Point Beach Nuclear Plant, Units 1 and 2
Dockets 50-266 and 50-301
Renewed License Nos. DPR-24 and DPR-27

Response to Request for Additional Information
License Amendment Request 247
Spent Fuel Pool Storage Criticality Control

RESPONSE TO REQUEST FOR ADDITIONAL INFORMATION LICENSE AMENDMENT REQUEST 247 SPENT FUEL POOL STORAGE CRITICALITY CONTROL

Figure 1 - Calculated k_{eff} (44-group Cross-Section Library) vs. $H/^{235}U$

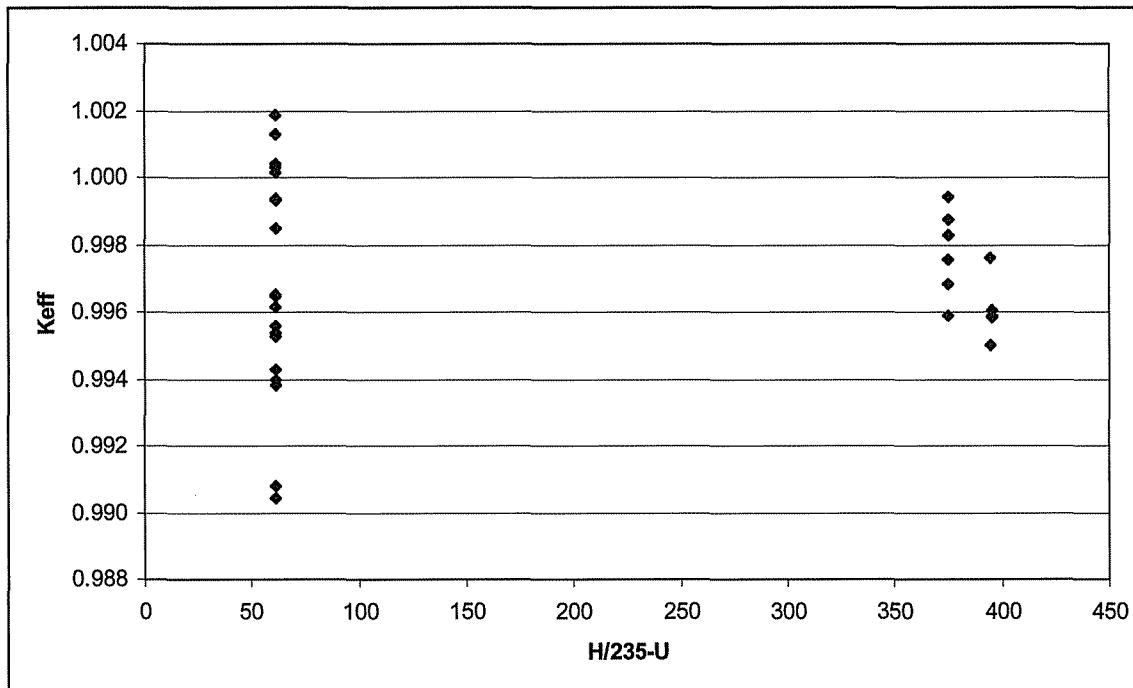
- a. Discuss and justify the method you used to select the benchmarks identified in Tables 1-1 and 1-2. For example, what parameters were considered to correlate the benchmarks to the systems being analyzed? What ranges were considered for those parameters?*
- b. Please provide additional details characterizing the benchmarks in terms of the parameters cited in Question 1a above, or submit References 9 through 12 of WCAP-16541-P, Revision 2. Currently, the submittal lacks sufficient information to evaluate the applicability of the benchmarks to the systems being analyzed.*
- c. Document and justify the area of applicability for the benchmarks.*
- d. Describe and justify any statistical and trending analyses performed to support the determination of the bias and bias uncertainty.*
- e. How did you account for the measurement uncertainties for the benchmarks?*

The calculated k_{eff} , using the 44-group cross-section library, of each of the thirty benchmark experiments was plotted versus the $H/^{235}U$ value of the experiment, and is shown in Figure 1.

The data is well distributed and no trend is apparent as a function of $H/^{235}U$. The results using the 238-group cross-section library showed similar distributions.

Figure 3 - Δk in the All-Cell Configuration

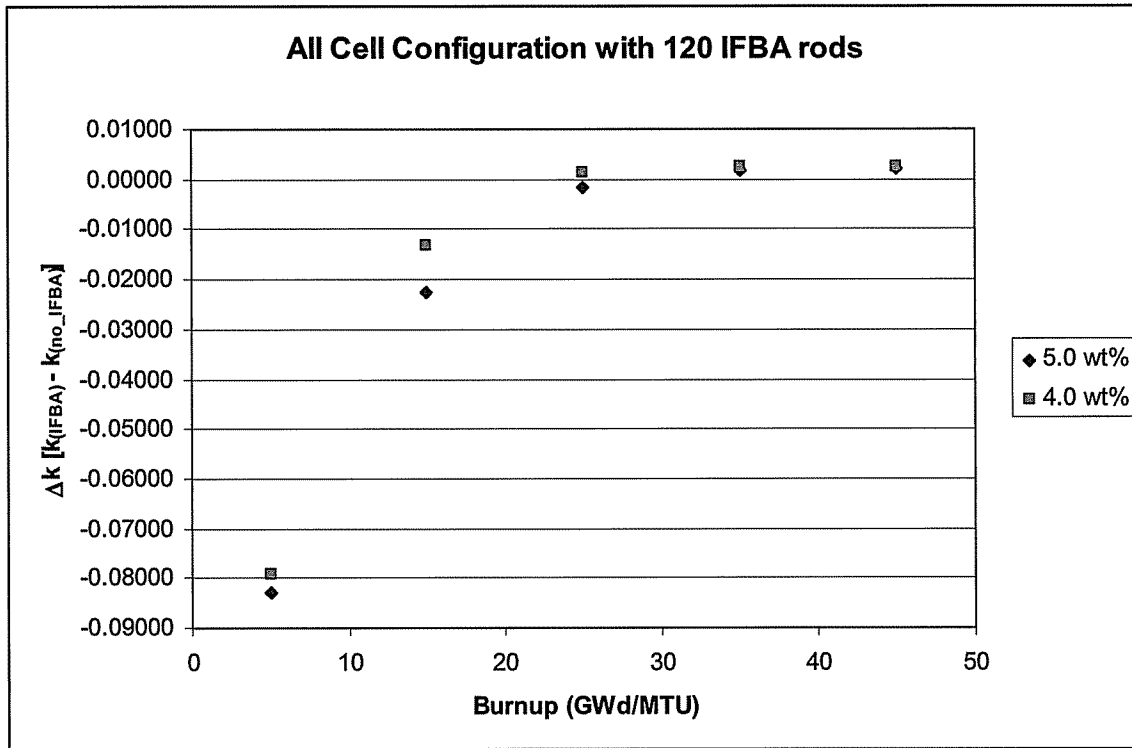
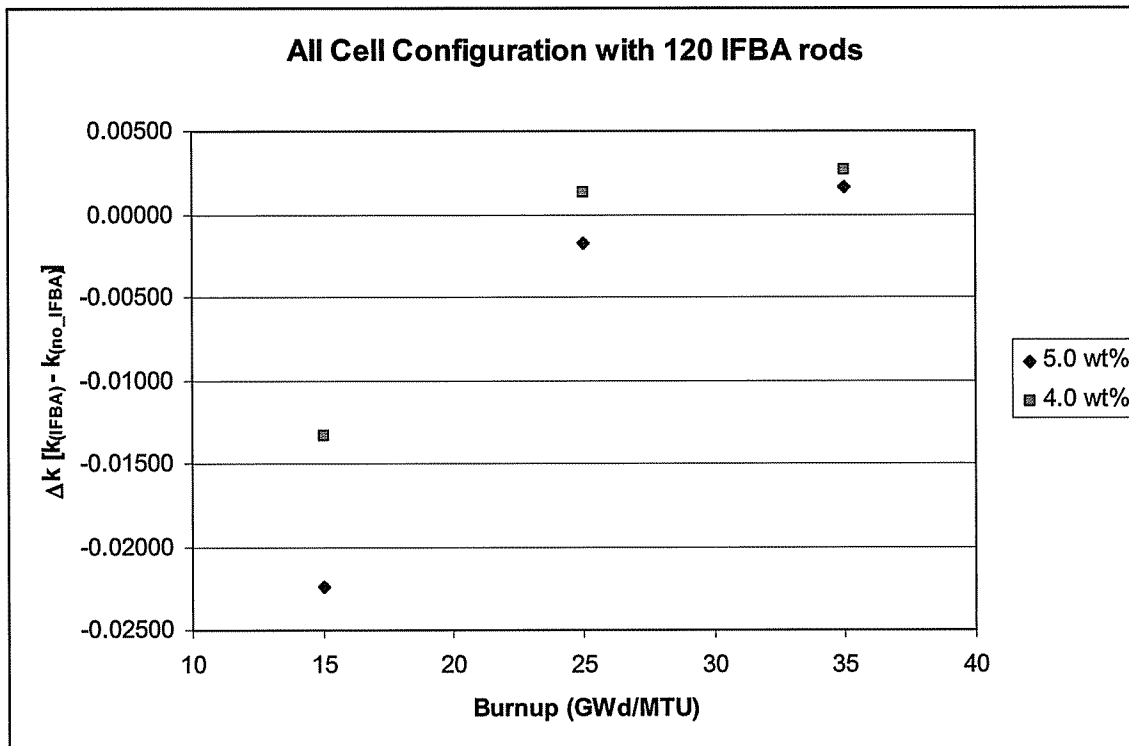
- a) *Letter dated September 19, 2008 (ADAMS Accession No. ML082630114), provided a response to the staff acceptance review. You state in response to Question 4, that the "results demonstrate that including the residual ^{10}B provides sufficient reactivity margin to account for the spectral hardening caused by the presence of IFBA during the depletion." This statement conflicts with NUREG/CR-6760 which states that "... the Δk values become positive for fuel assembly designs containing IFBA rods but remain negative for gadolinia-bearing fuel assembly designs." NUREG/CR-6760 further states that "... analyses show that there is a negative residual effect for gadolinia-bearing fuel but no such effect for fuel designs with IFBA rods." Please resolve the difference in conclusions between your analysis and that of NUREG/CR-6760.*

- b) *What enrichment was used for the calculations in the table titled, "Results of Calculations with IFBA Present During Depletion?" Please justify that the results are based on the limiting enrichment and burnup combinations.*

Some similar trends are seen between the two analyses. Figure 41 in Section 3 of NUREG/CR-6760 shows Δk values versus burnup for the 156 IFBA pattern, with varying ²³⁵U enrichments. Table 8 below shows similar trends for the 120 IFBA pattern, with varying ²³⁵U enrichments in the All-Cell configuration of the PBNP analysis. The values shown in this table are plotted in Figures 3 and 4.

The data was fit using a fifth order polynomial and the difference in eigenvalues was found for the All-Cell configuration burnup limits for 4.0 wt% and 5.0 wt%, reported in Table 4-1 of WCAP-16541-P, Revision 2. The difference in eigenvalues at the burnup limits is shown in Table 9. For this site specific analysis, at the burnup limits specified in WCAP-16541-P, Revision 2, the residual IFBA is enough to overcome the effect of spectral hardening. The results confirm that neglecting the presence of IFBA is conservative in the All-Cell storage configuration.
